**Addendum No. 2
February 16, 2023**

Project: Harrisburg Elementary School #8
Harrisburg, South Dakota
Architecture Incorporated Project #3000

Architect: Architecture Incorporated

REFLECTED CEILING PLAN - AREA A
SCALE: 1/8" = 1'-0"

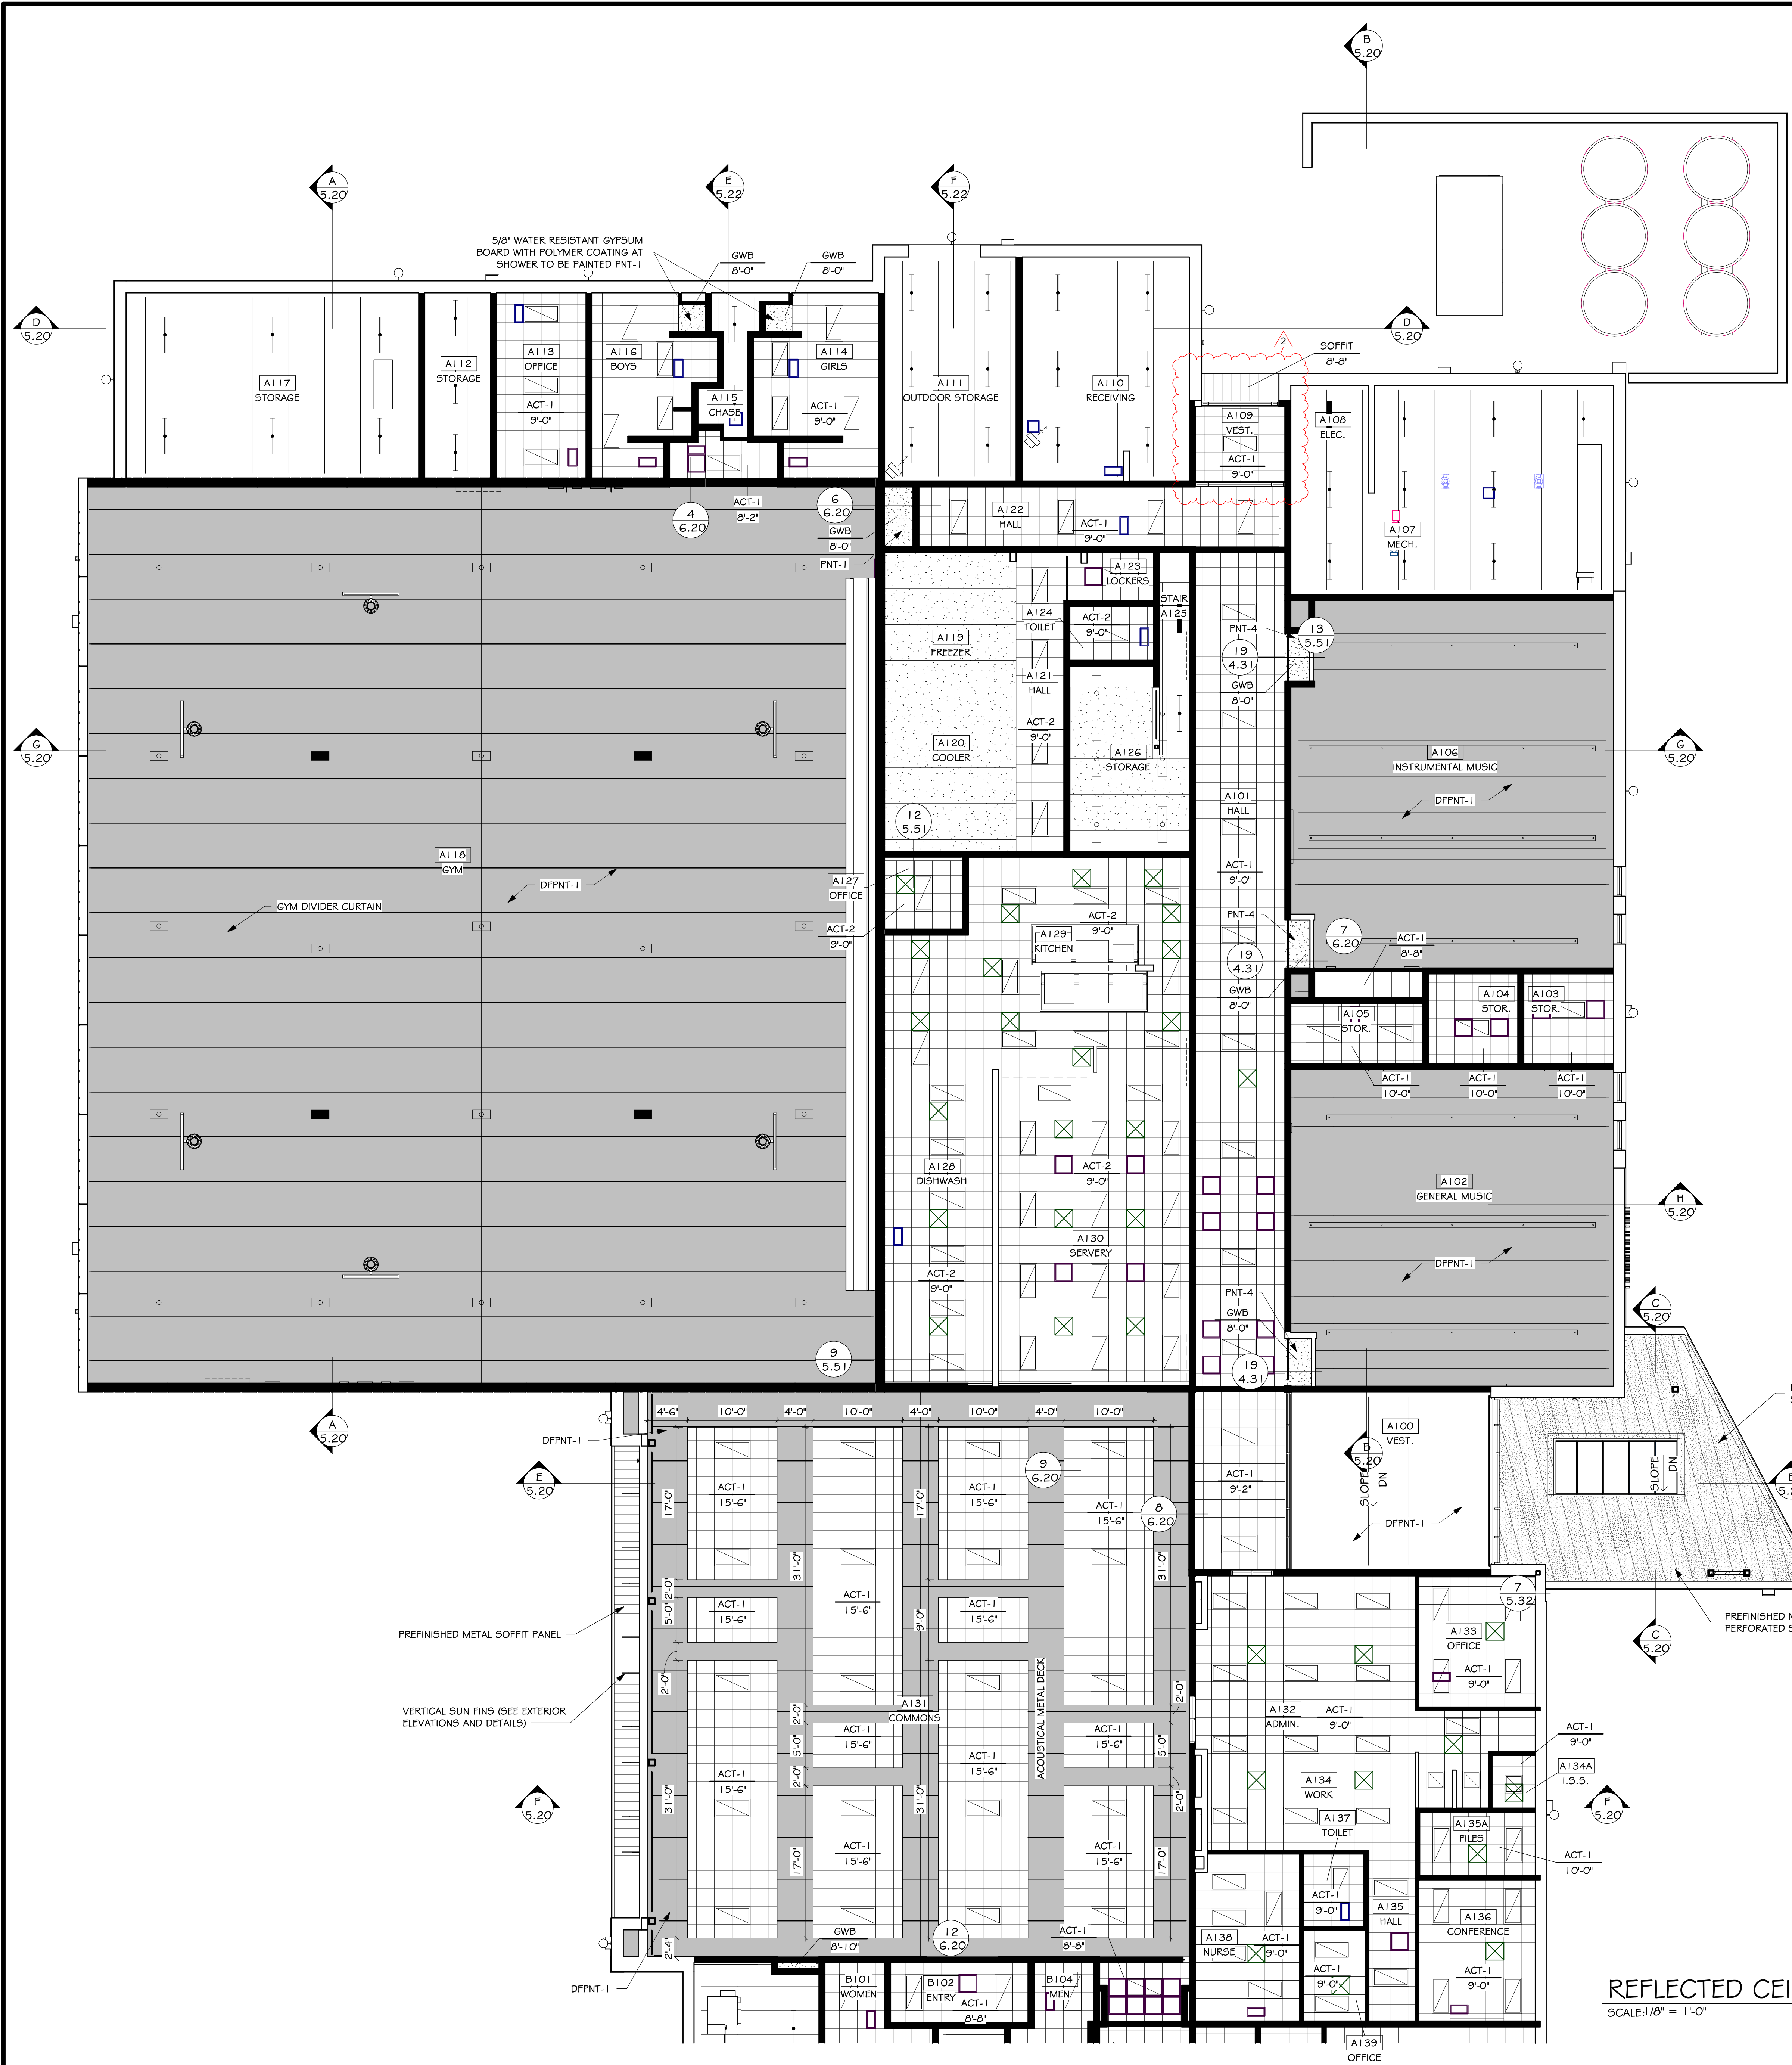
- a) Modify the ceiling grid layout and the location of the light fixture in VESTIBULE 109 as indicated per *revised* drawing Sheet 6.10, dated 2-16-23, attached to the end of addendum.
- b) Furnish and install prefinished metal soffit panels above the entrance alcove located north of door A109-1 as indicated per *revised* drawing Sheet 6.10, dated 2-16-23, attached to the end of addendum.

FLOOR PLAN AREA "B" - PLUMBING & HEATING
 SCALE 0 4 8 12 16

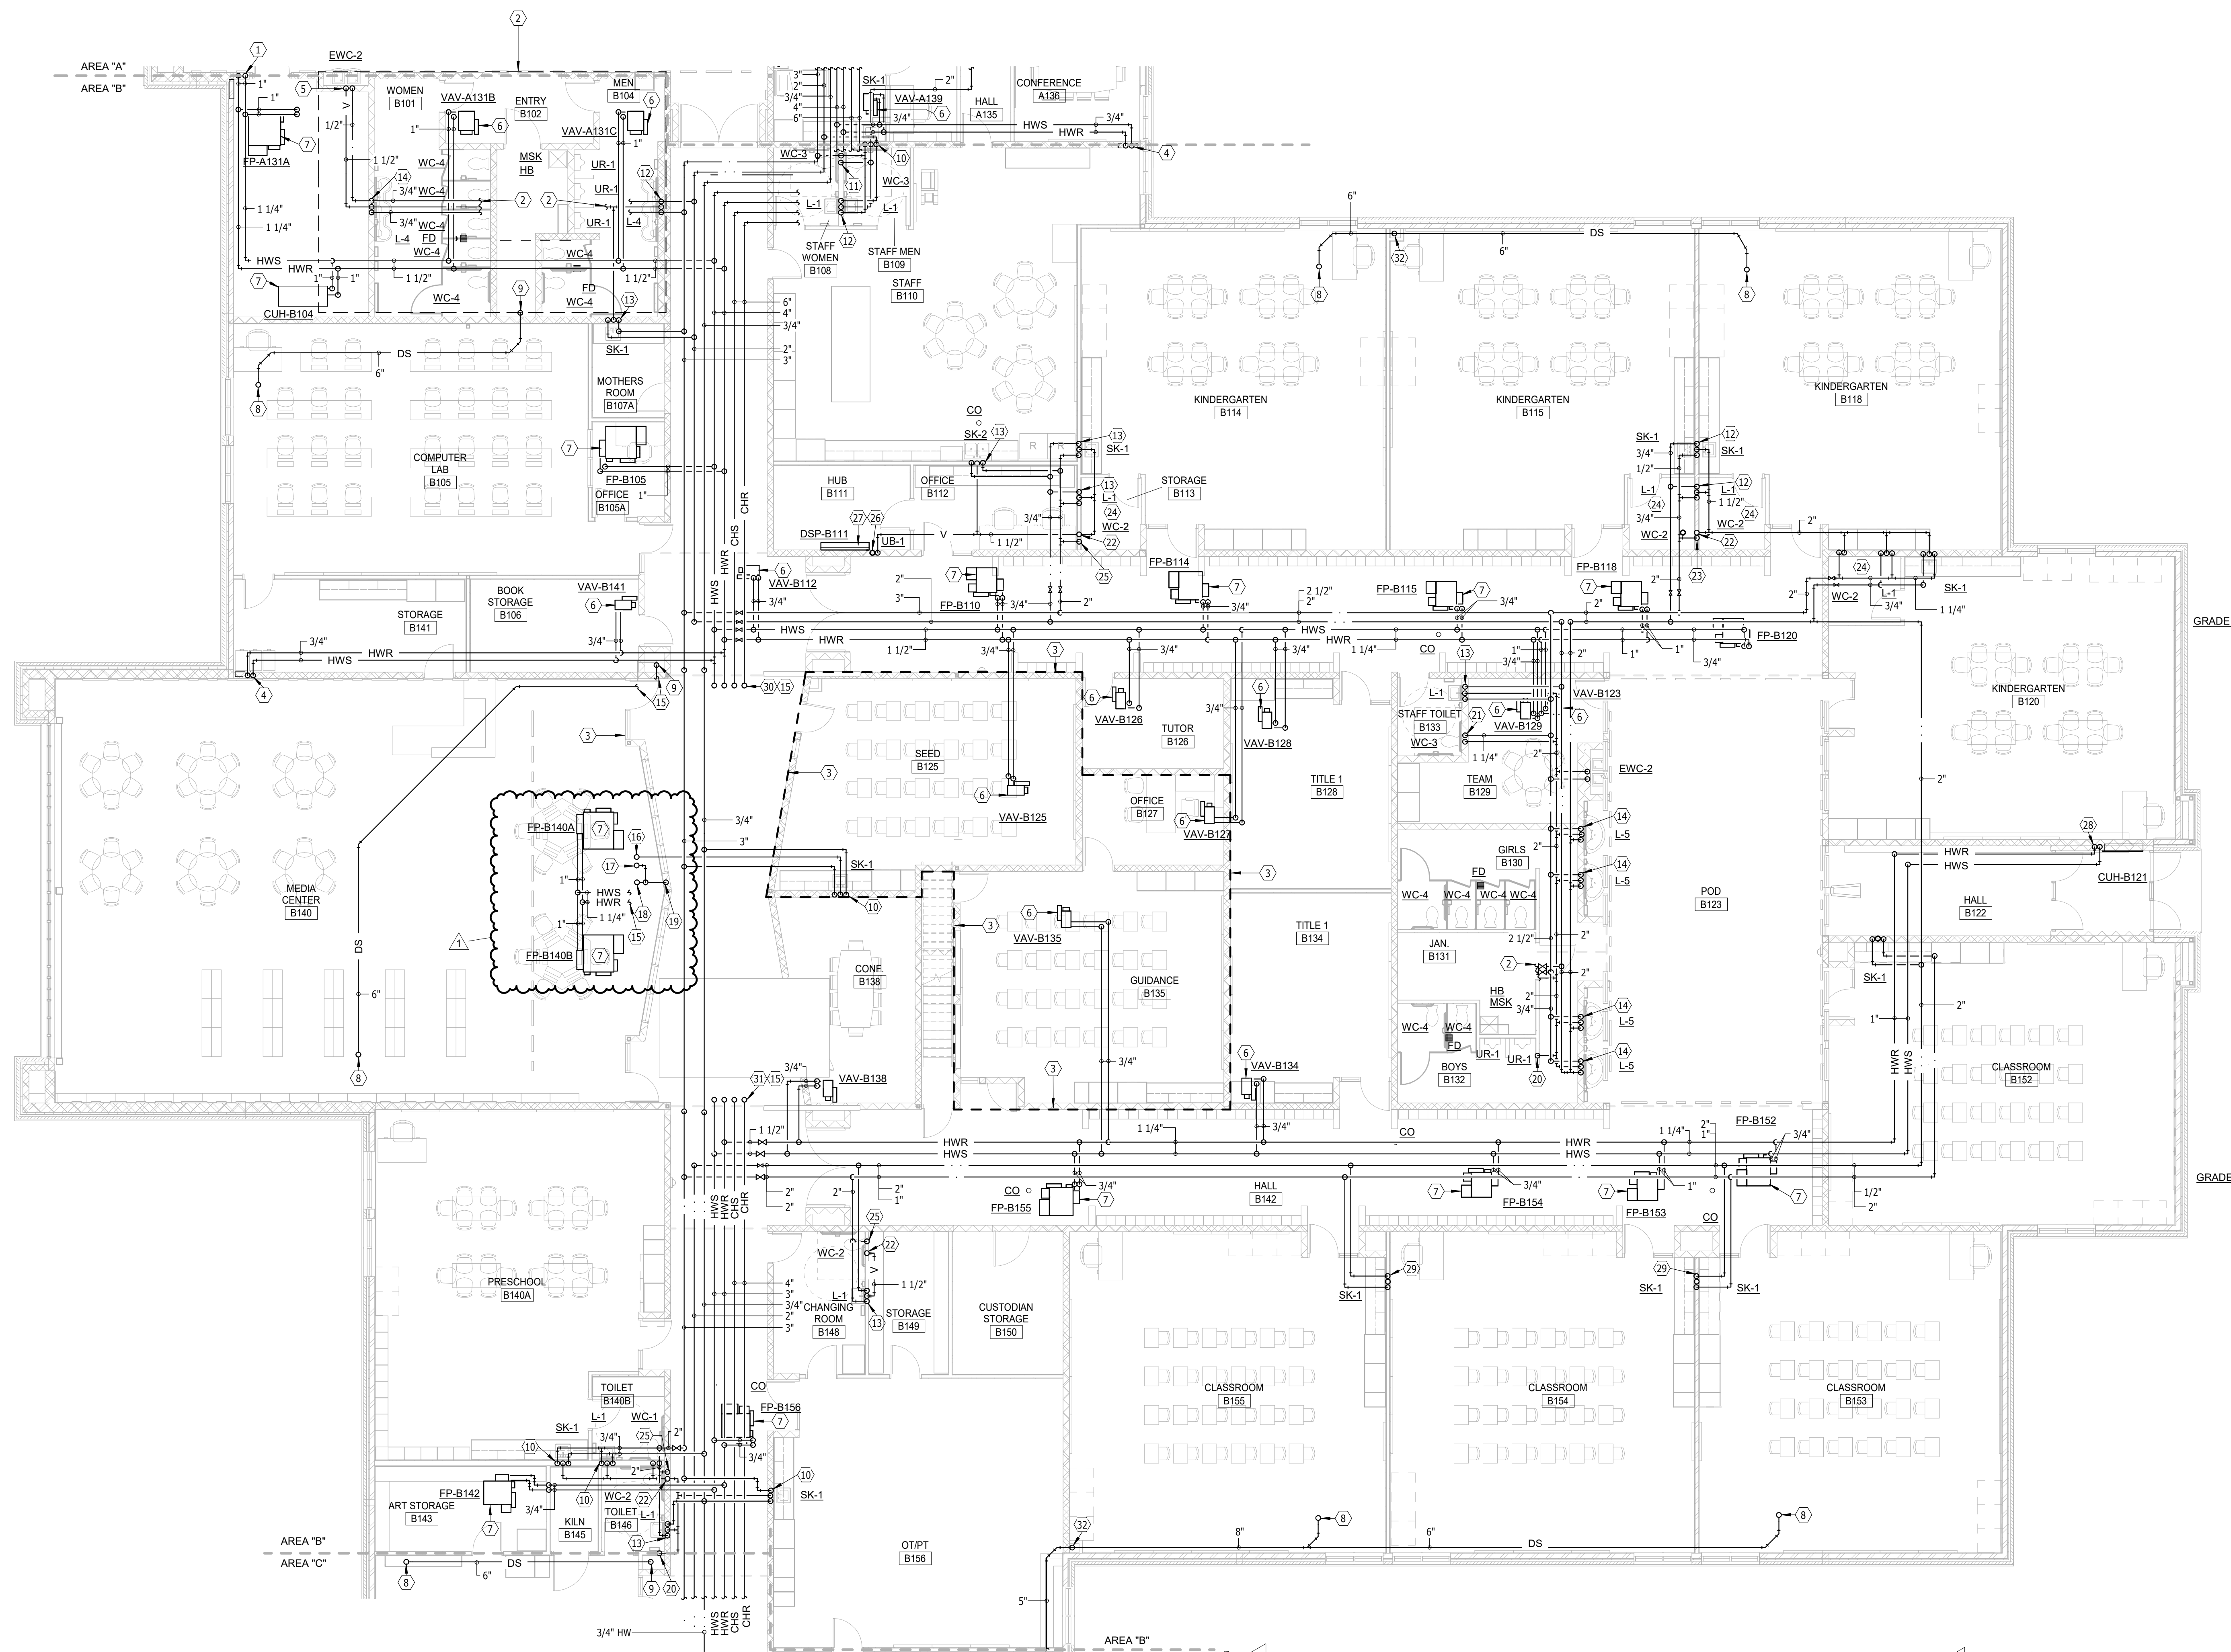
- a) Add FP-B140A and B140B and associated piping. Reference *revised* mechanical drawing Sheet 8.25, dated 2-16-23, attached to the end of addendum for additional information.
